**City of Phoenix**  
PLANNING AND DEVELOPMENT DEPARTMENT

**Staff Report Z-6-19-1  
September 4, 2019**

**Request To:** RE-35 Hillside DNS/WVR (Single-Family Residence District, Hillside Density Waiver) (60.50 acres)

Figure H. Maximum Gradable Elevation, 1610' Above Mean Sea Level

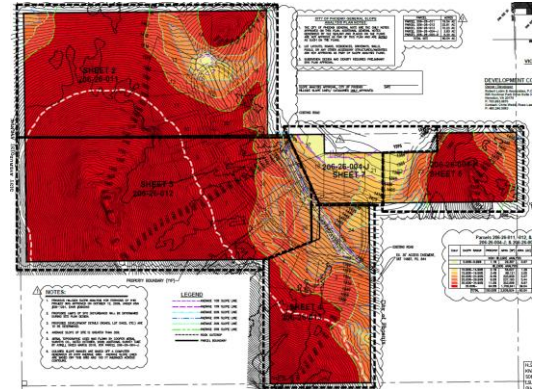
- A maximum building envelope disturbance area of 400,000 square feet. Stipulation No. 2.
  - Section 710 would restrict grading to a maximum of 35% of the total site area or 20,000 square feet per unit; the disturbance maximum proposed is based on the allowed per unit disturbance of 20 units, rather than the 32 requested.
- A maximum elevation for grading disturbance of 1,610 feet above mean sea level. Stipulation No. 4.

4. There shall be no grading permitted at an elevation of 1,610 feet above mean sea level or above. The remainder of land shall remain undisturbed and be preserved as natural desert open space, as approved by the Planning and Development Department.
5. The color and material palette for the buildings shall be determined at site plan

Figure L. Proposed Off-Site Improvements

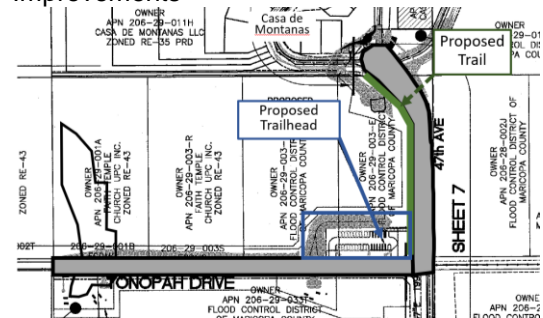
The conceptual site plans also propose: the completion of Tonopah Drive from its current terminus to 47th Avenue to provide another access; the construction of a bicycle and pedestrian trailhead at the northwest corner of 47th Avenue and Tonopah Drive; and the construction of a 10-foot “detached trail” to where the service road deviates toward the Adobe Dam. These off-site improvements are depicted in Figure L.

The proposed improvements depict a “10-foot detached sidewalk” at the above location; however, staff recommends the pedestrian route comply with the specifications of a multi-use trail easement and trail.

Figure M. Typical Elevation (Uphill Prototype Elevation)

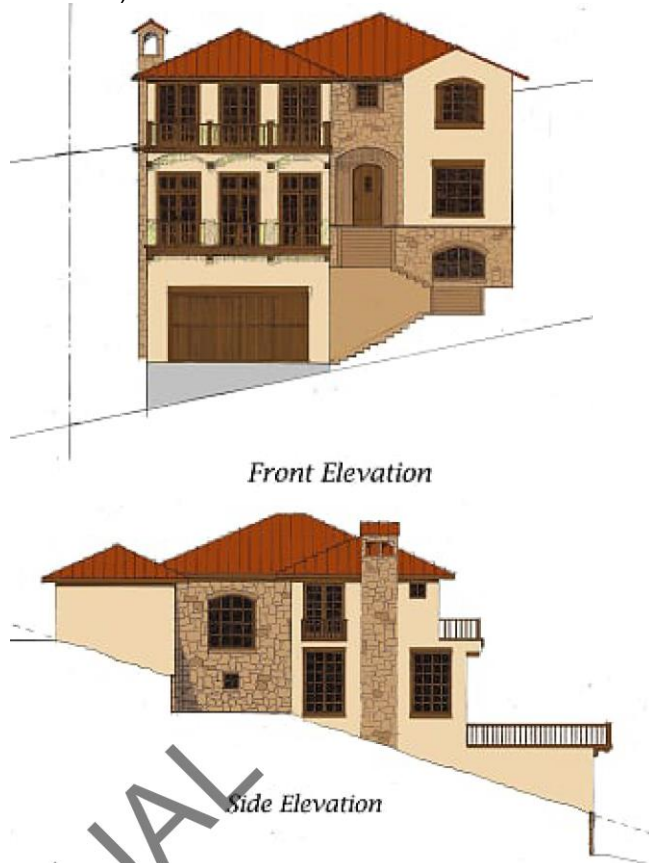
Building Height	2 stories and 30 feet	2 stories, not to exceed 30 feet above the natural grade of the lot or parcel at any section through the structure.	Conceptual building elevations do not appear to comply with hillside height requirement. (Not Met)

The height requirement of Section 710 is a maximum of two-stories, not to exceed 30-feet above natural grade. It appears several of the conceptual elevations may not comply with this requirement.

**CONCEPTUAL SITE PLAN**

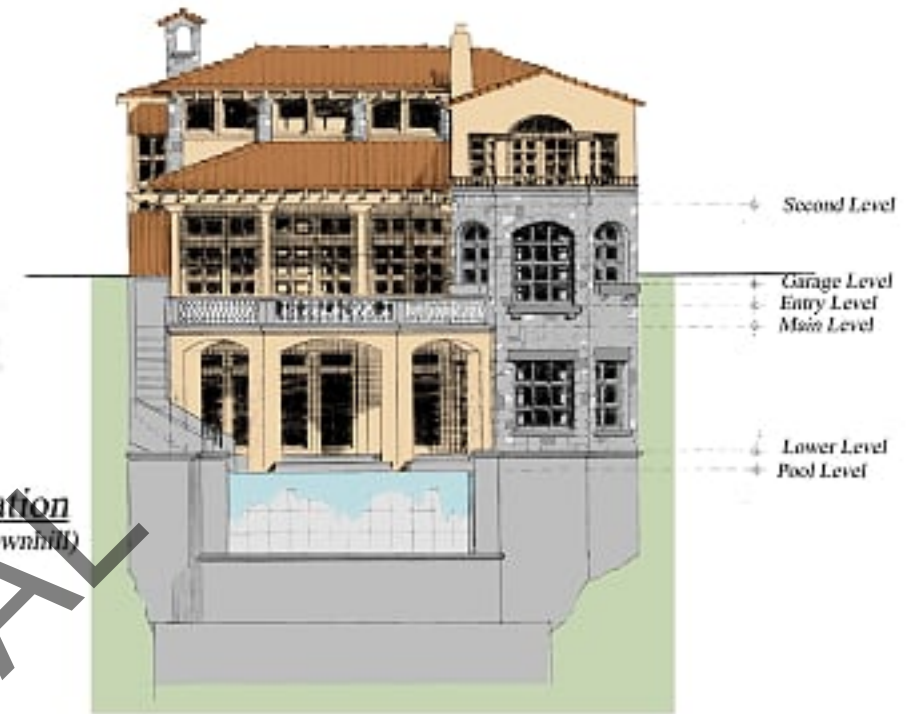
8. The conceptual site plan proposes graded building envelopes rather than fully graded lots to increase hillside preservation. The conceptual site plan also situates hillside development lots below the ridgeline. Staff recommends two stipulations to minimize the amount and visibility of disturbance.

9. The request proposes both an increase in dwelling units per acre and an increase in the number of dwelling units permitted in each slope category. Figure I compares the proposed density waiver to the density permitted by the slope analysis. The additional 12 units impact the unit counts in each slope category, but the following impacts are most notable:

- Fewer units proposed than permitted in slope categories less than 20%: A decrease of 4.35 units from the slope analysis due to much of the lower slope area being used for internal street circulation.
- More units proposed than permitted in slope categories greater than 19.9%: An increase of 14.83 units from the slope analysis.
- Most significant increase in the number of dwelling units is in the 30 to 34.9% slope category: An increase of 6.91 units from the slope analysis.

1. There shall be a maximum of 32 dwelling units.
2. There shall be a maximum overall building envelope disturbance area of 400,000 square feet, as approved by the Planning and Development Department.
3. There shall be no more lots, dwelling units, or building envelopes created than permitted by the slope categories provided below, except that lots or dwelling units not placed in a slope category may be placed in a lower slope category so long as the total number of lots or dwelling units in the hillside development area does not exceed 32 units, as approved by the Planning and Development Department.
